gProjects Y13

townhomes at 2707-2711 east yesler way

section 3.0 development objectives

section 8.0 response to edg

PARKING DIAGRAM
no scale

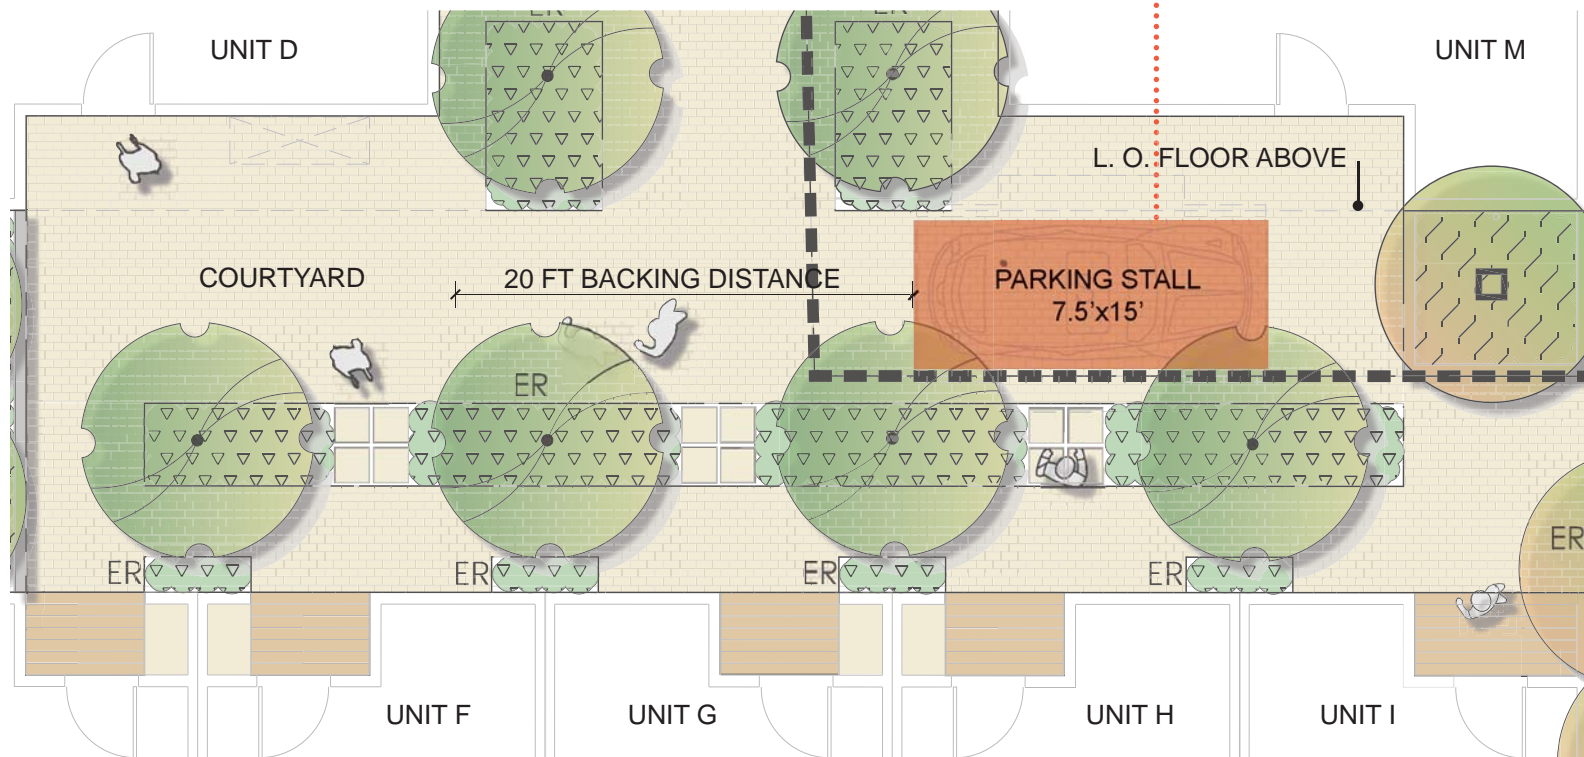
a. The Board wondered if parking should be situated in the front units so paving doesn't have to come so far into the site and the dumpster location could be centralized. (DC1-C)

b. The Board was concerned about the functionality of the parking due to the width of the carports.

c. The Board suggested that it might be better to have a separate dedicated pedestrian access or develop further the central access as a woonerf. (PL1-B)

Response:
 The design team investigated these alternate carport parking locations:
 1. Within the north units accessed from the south side; and
 2. Within the central courtyard units, accessed between the street front units and the courtyard units.

Because of these issues and further staff clarification on "totally enclosed parking" the project now proposes a single surface stall. This maintains the maximum amount of open ground space dedicated to resident amenity area, establishes the safest and most functional access to parking and the entire site, and maintains 4 street facing units with direct access to the north and south. Land use requirements dictate trash & recycling areas must be accommodated on each development parcel so the common dumpster location along the east side yard has been changed to a continuously landscape side yard. Trash and recycle storage is provided in alternate locations, according to the site plan.

Response:
 The parking is designed for a small stall with code required backing distance and aisle maneuvering clearances. Landscaping, including trees, has been strategically located to clear turning radius maneuvering for the stall. The ground level of the Building 2 and 5 units has been pulled back to increase the overall width and openness of the central courtyard.

Response:
 Given the single parking stall the design team has accentuated the pedestrian nature of the central space with additional landscaping and proposes a woonerf environment with permeable paving, landscaping, and architecturally integrated lighting. The central pedestrian movement will create a strong communal identity for the development and reduce impacts on neighboring properties.

Streetscape

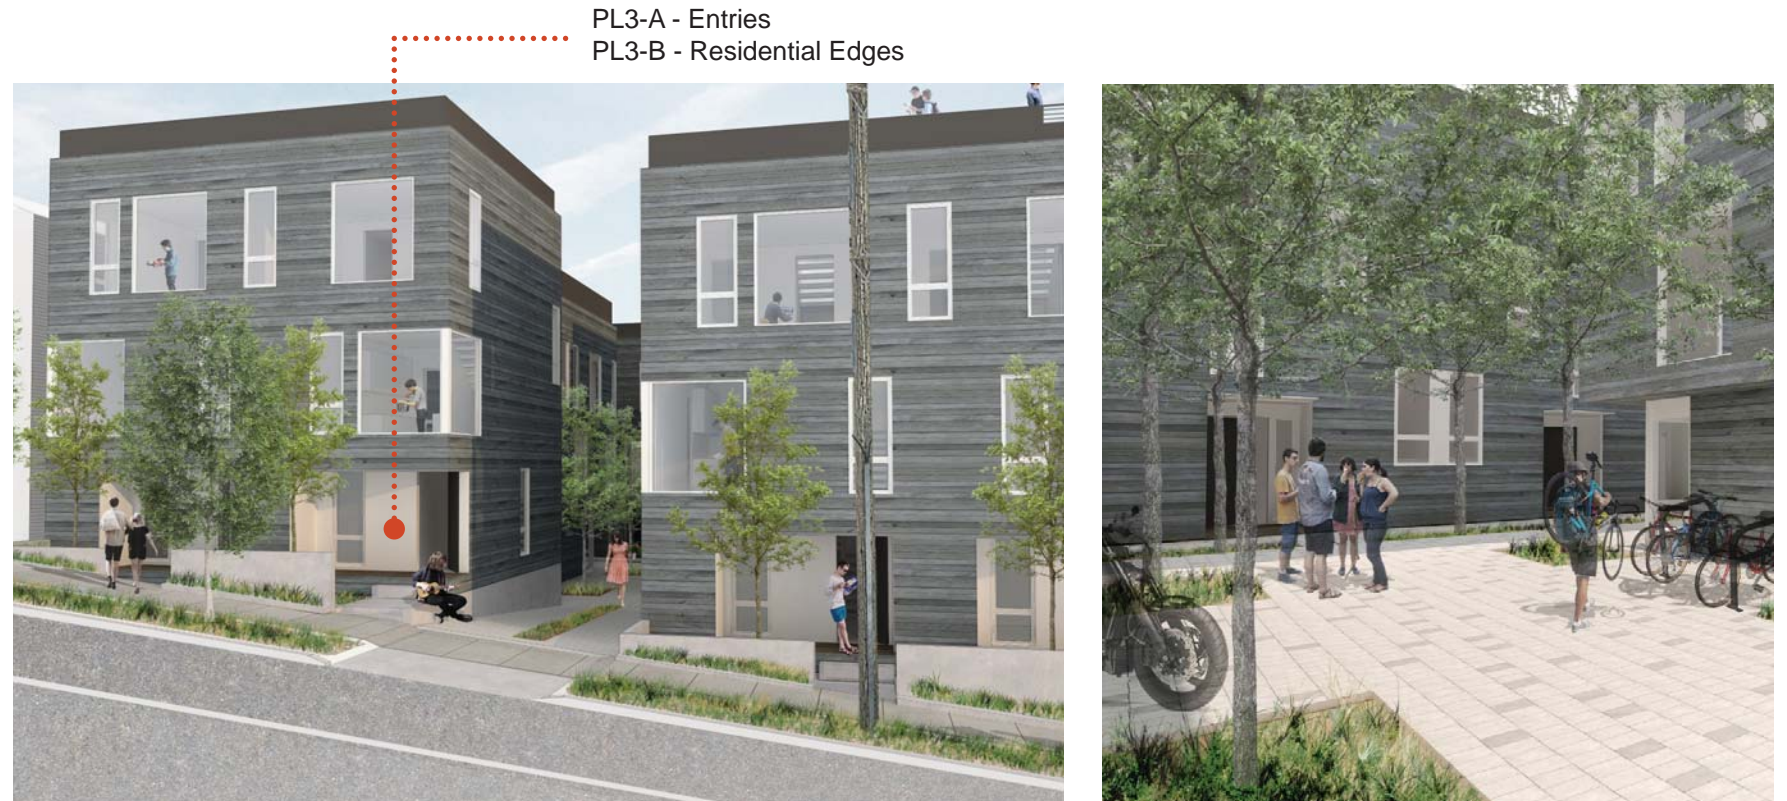
a. The Board agreed that the stoops, landscaping, and simple façade design presented in the cover rendering of the front elevation were heading in the right design direction. (CS2-C, PL3-A, PL3-B)

Response:
Entry stoops and landscaping strategies have been developed further to create a layered transition from the public to private realm. All unit entries are recessed for project consistency and weather protection. The landscaped courtyard, complete with trees and permeable paving, is conceived as a hardscaped garden environment. The simple building massings, large windows, and stained wood siding is consistent, elegant, and responsive to the scale of the neighborhood and the broader region.

Trash

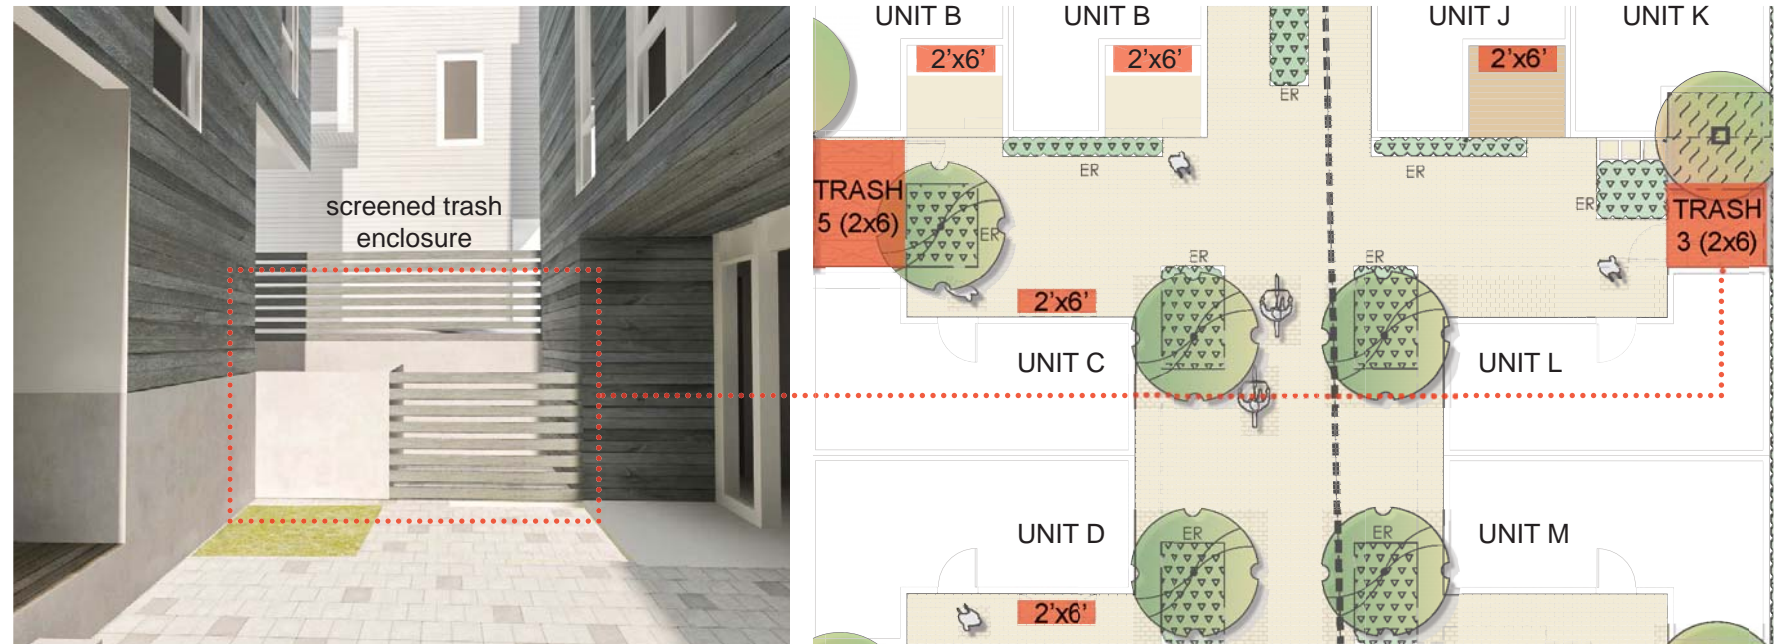
a. The Board was concerned about the location of the trash as it was next to the entrance to one of the units and the trash for every unit must be carried to the northeast corner of the site on collection day. (DC1-C)

Response:
Due to SDCI and SPU code requirements, the central trash storage area along the east side yard is not permissible. There are two development parcels and each needs to conform to the city's land use code requirements. The larger Parcel Y (western portion) proposes a screened storage area between Building 1 and 2 along with individual storage areas for Units A, B, C, and D at those units per the site plan. Parcel Z (eastern portion) screened storage area is proposed between Building 4 and 5 with individual storage for Unit J at its back door. This provides more landscaping in the east side yard and establishes a greater connection through the center of the development for resident interaction as they move through the site. All on site storage areas are as close to the street as possible while creating the least impact on the courtyard environment and the neighboring properties.

3024790 PARCEL Y

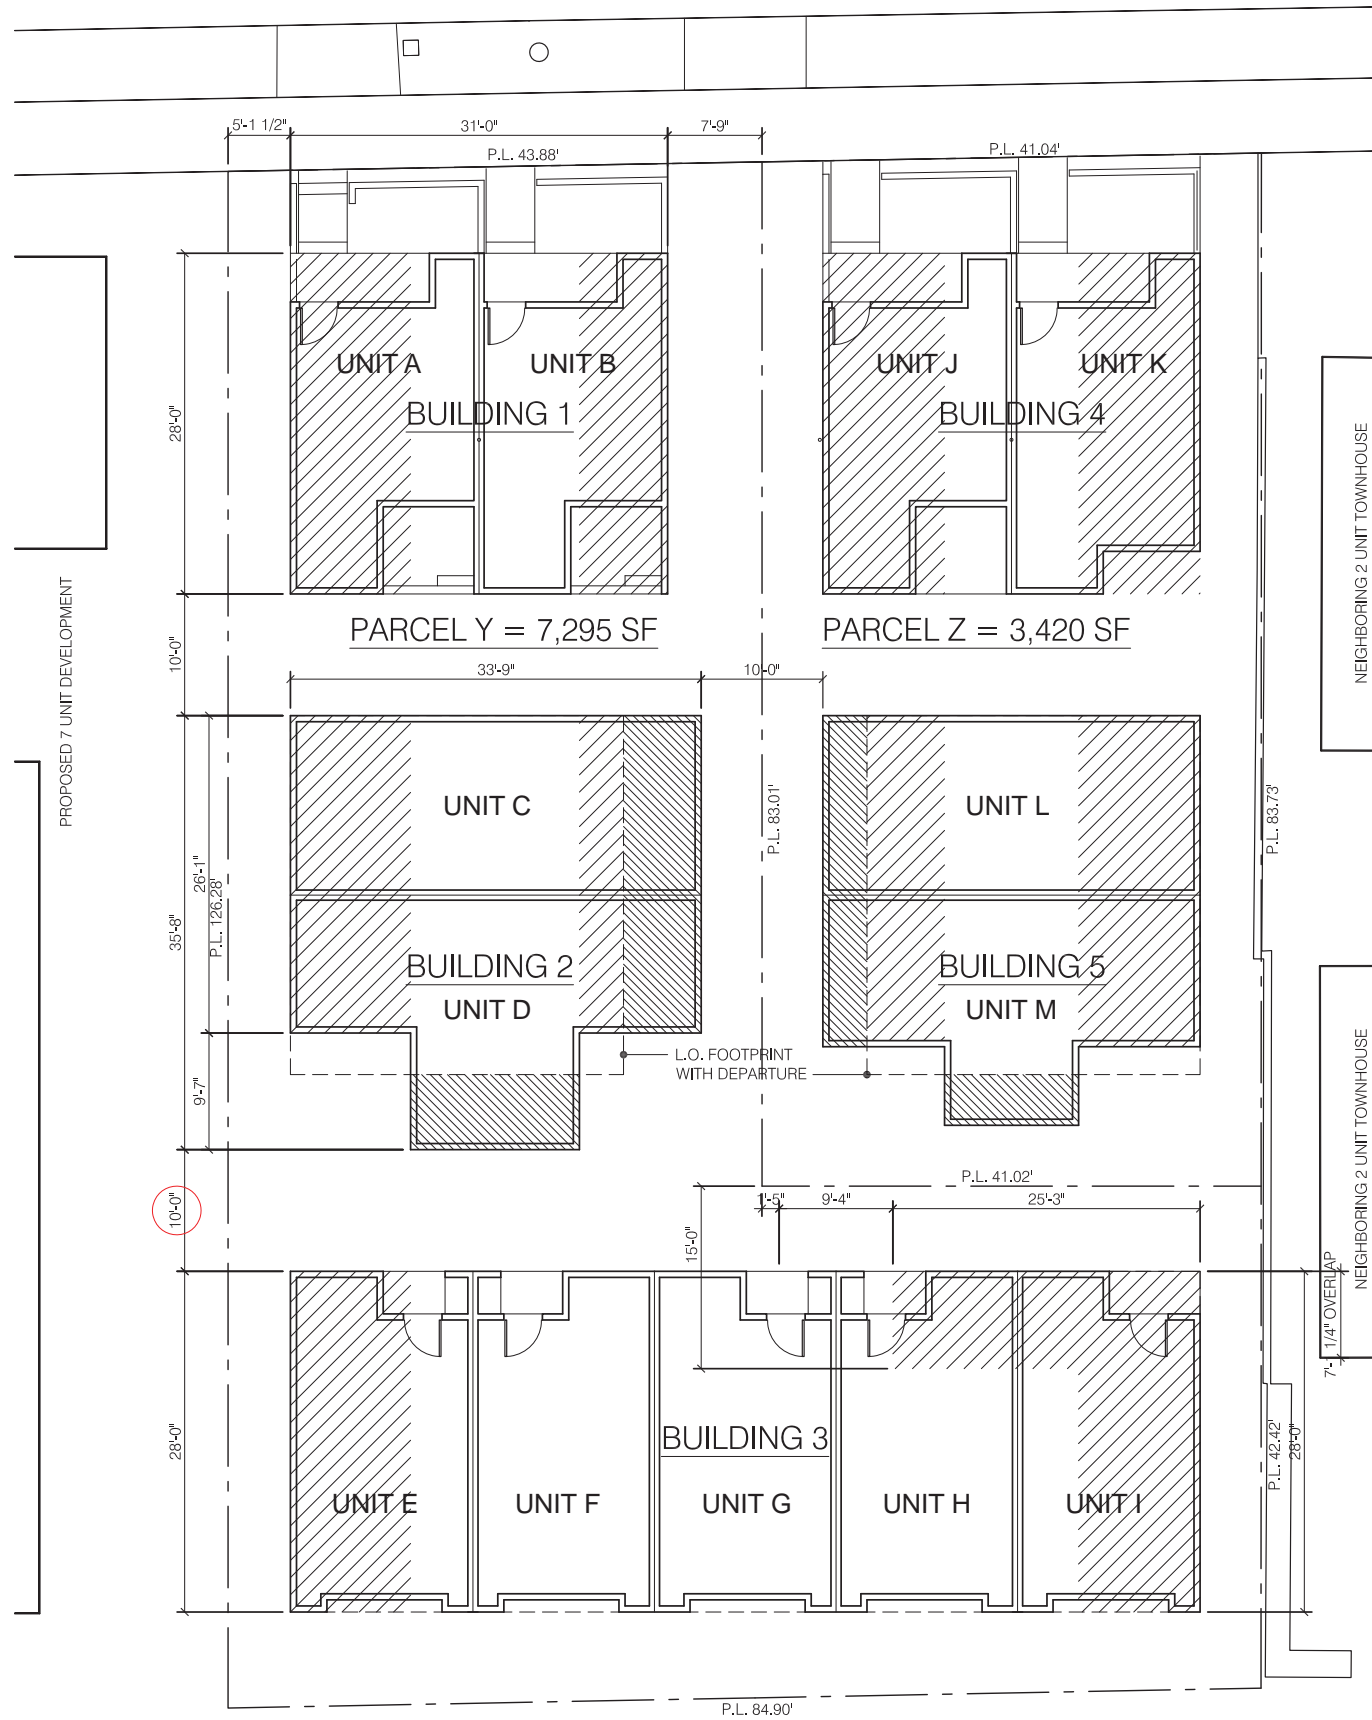
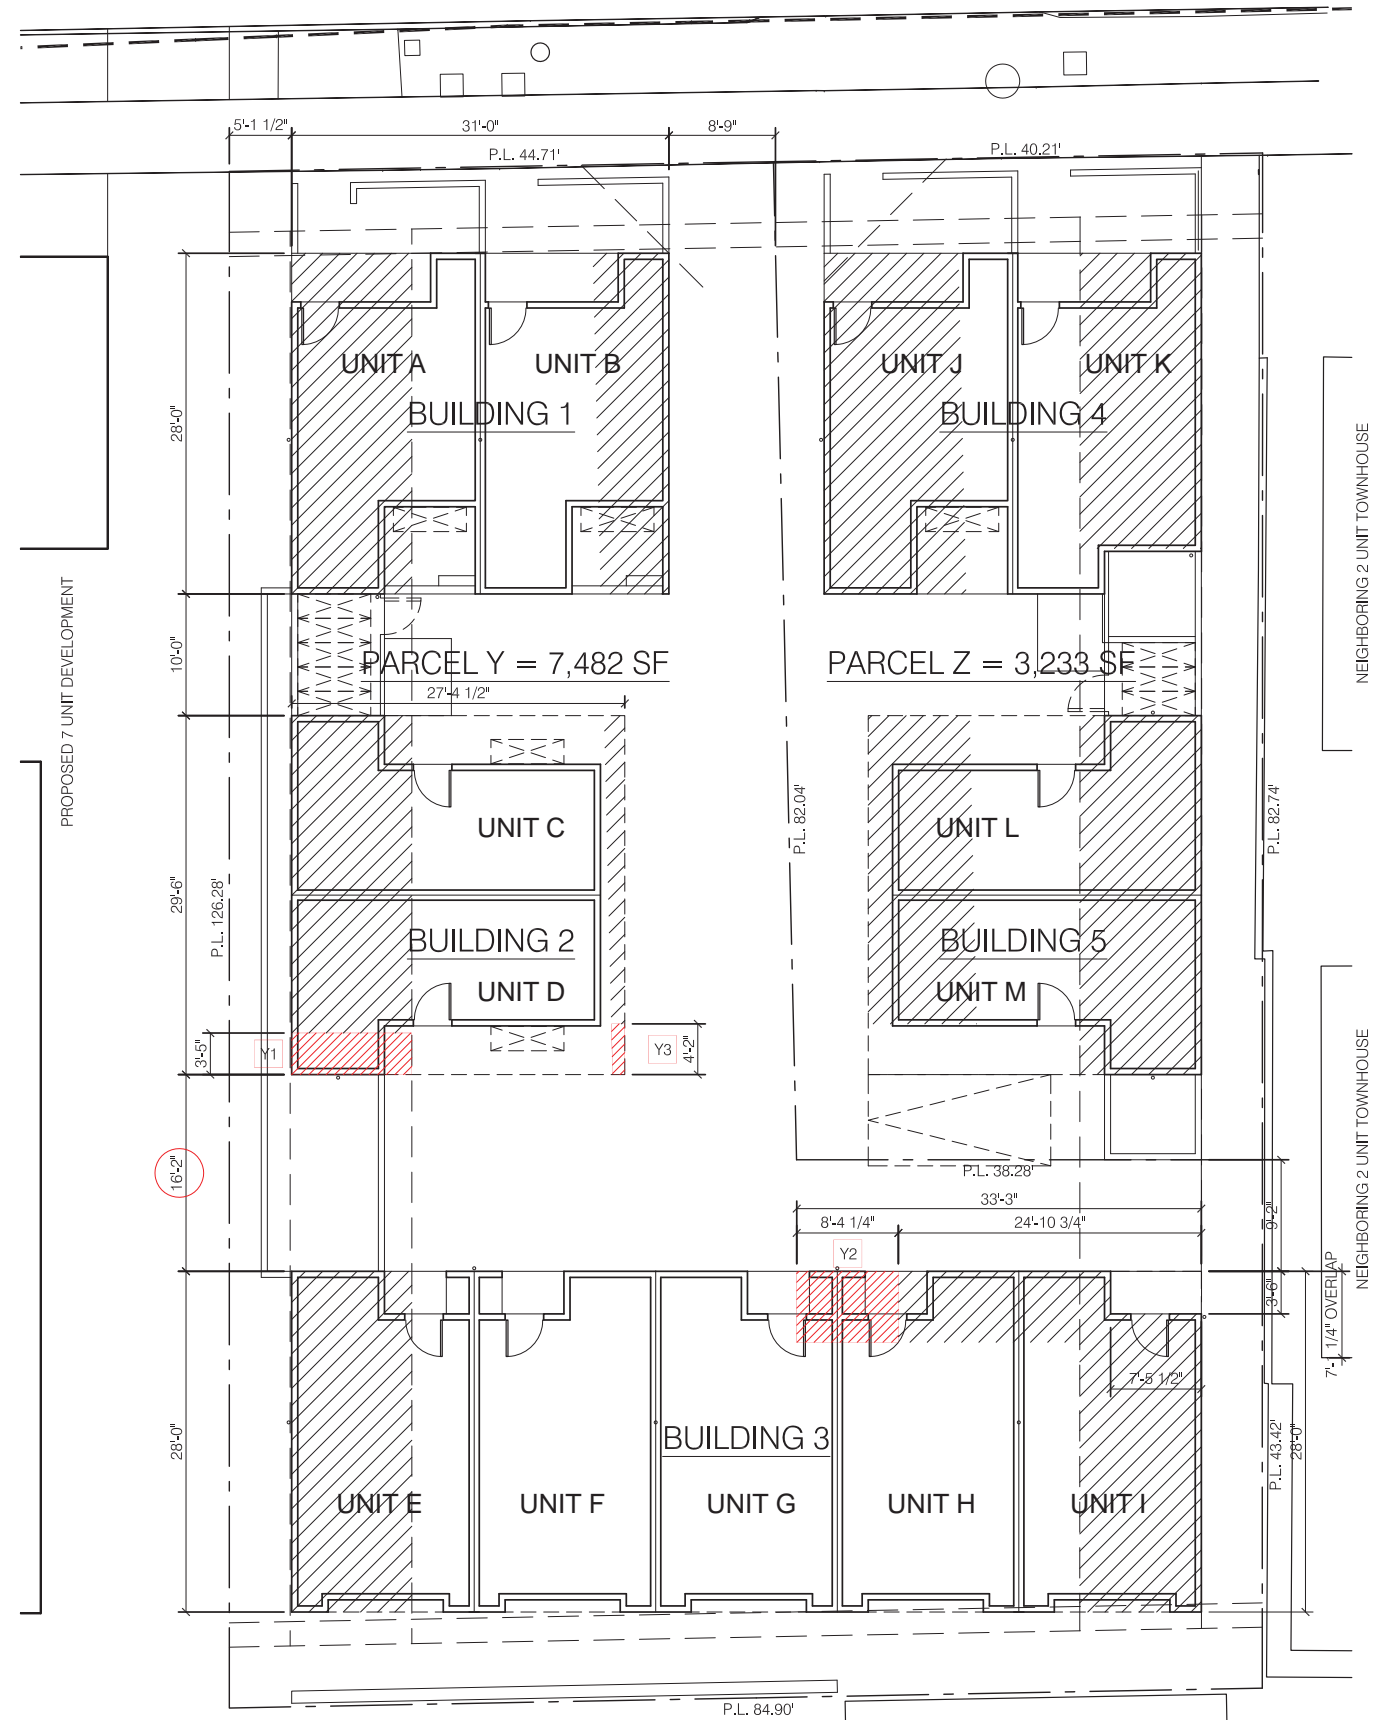
1. The project seeks a departure to maximum facade length at Parcel Y.

Y1. Parcel Y west facade Bldgs 1-3 = $126.28' \times 0.65 = 82.08'$

Y2. Parcel Y north facade Bldg 3 = $38.28' \times 0.65 = 24.88'$

Y3. Parcel Y east facade Bldgs 1-2 = $82.04' \times 0.65 = 53.33'$

Justification: Y2 and Y3 are a result of an interior line created through the LBA. As a single project Bldgs 1, 2, and 3 are all conforming or greater than the requirements of 23.45.518.f. separation between multiple structures (see requested departures plan).

A conforming and functional floor plan would require Bldg 2 to step at the facade length limit, then project to minimum interior separation distance once the facade is greater than fifteen feet from the lot lines. This will create reduced building separations across the project, diminish the quality of open space, create functional layout issues within units, and reduce the width of view corridors for the neighboring properties through the proposed project's open spaces. This is particularly apparent in the case of the neighboring townhome to the southeast (see east elevation window & door areas).
